DSO6104L-01-S

# Safety Service Note

## DSO6104L Oscilloscope, LXI, 4-channel, 1 GHz

### POSSIBLE "SHOCK" HAZARD

**Figure 13** Removing the cover

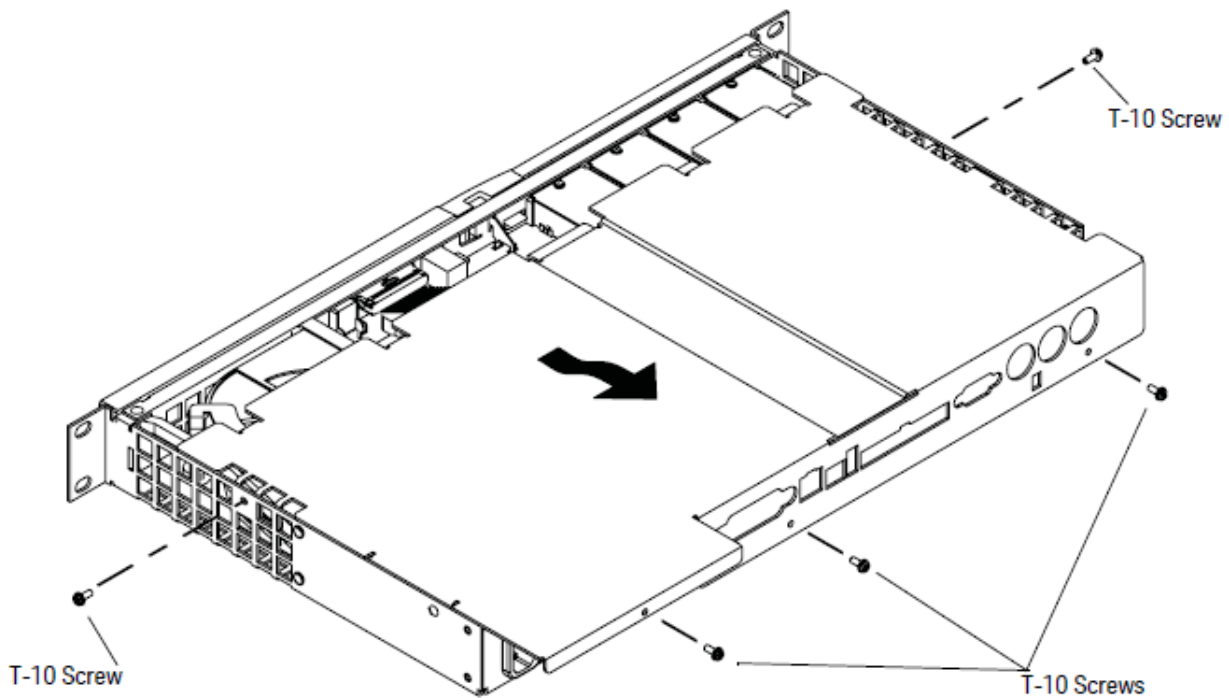
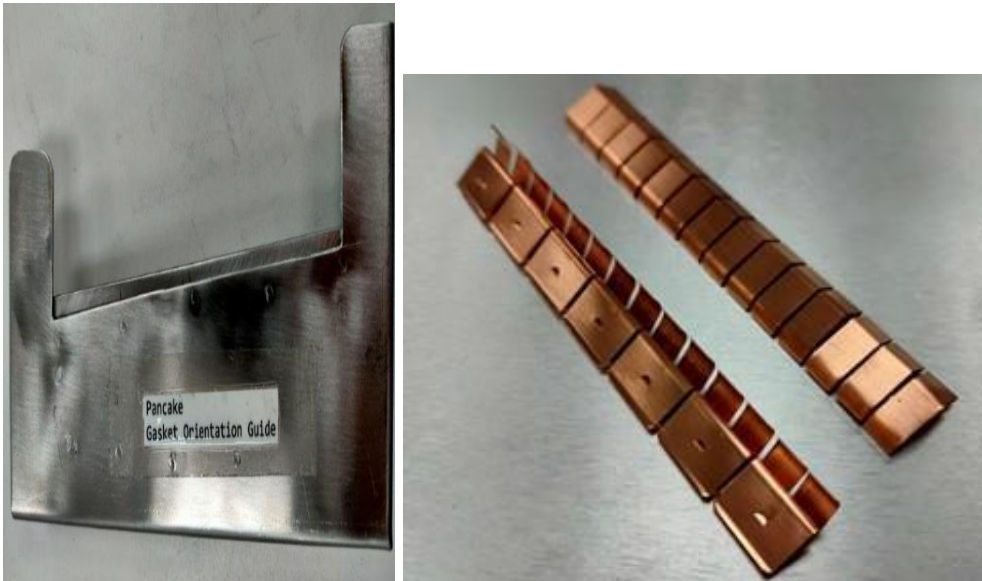
**The Problem** – A Foam Filled EMI Gasket was used in the units listed above. It was implemented in a total of 52 6000L units starting in Nov'2019 with SN: MY5945xxxx in response to a change in EMI qualification. It has been found that the Foam Filled EMI Gasket, if placed incorrectly, may not meet the safety creepage and clearance requirements and could cause a safety risk to the user.

The current Foam Filled EMI Gasket (implemented in Nov 2019) in the 6000L series scopes was placed incorrectly and may not meet the safety creepage and clearance requirements and could a cause safety risk to the user, therefore the cover assembly and EMI Gasket need to be replaced. **This is ONLY APPLICABLE FOR the units with the designated serial numbers which will be RECALLED back to SSU for repair.**

- replace the existing Cover Assembly with a new Cover Assembly without the foam EMI gasket
  - and to apply a new clip-on EMI Gasket Fingerstock (D6104-00104) to the affected units.
1. Remove and scrap the original cover assembly (D6104-00104) with the foam EMI gasket from the scope.
    - Turn off the oscilloscope and disconnect the power cable.
    - Turn the oscilloscope so the bottom is facing up.
    - Using a T10 screwdriver, remove 5 screws from the rear and sides of the cabinet.
    - Slide the bottom cover back and up to remove.

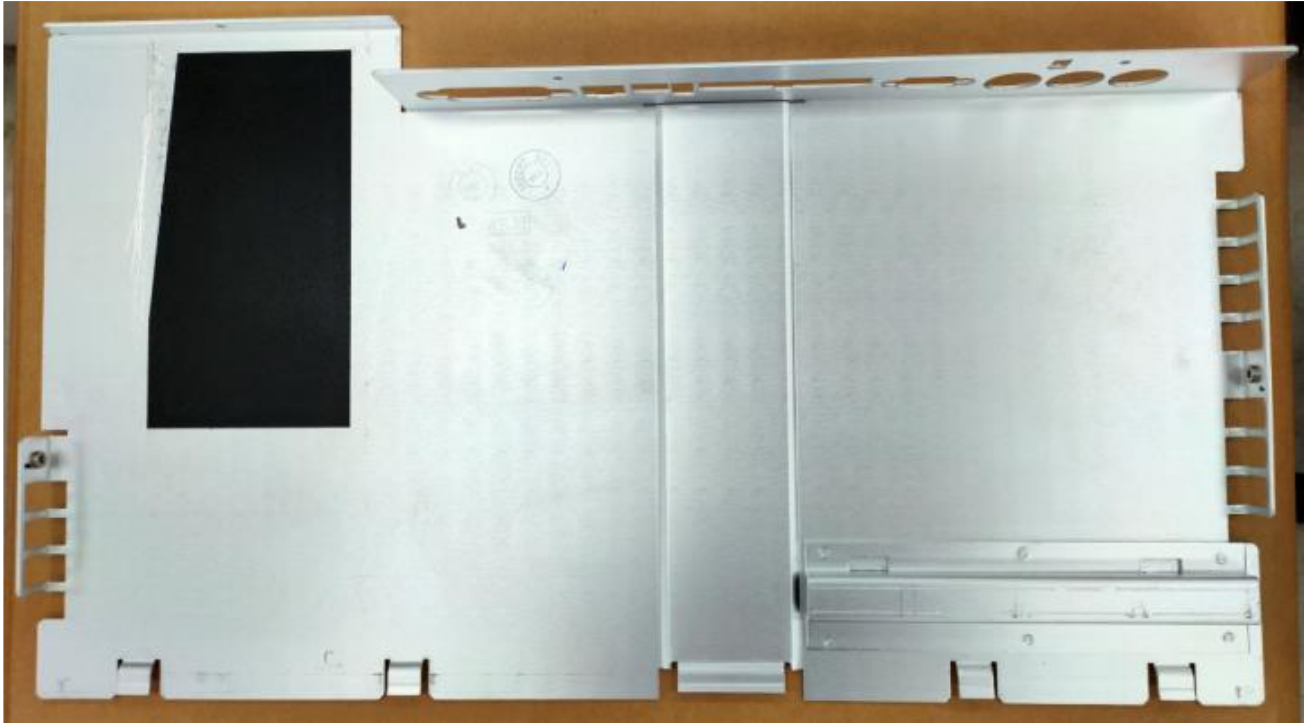
Example of **WRONG** placement of EMI gasket Fingerstock as below:
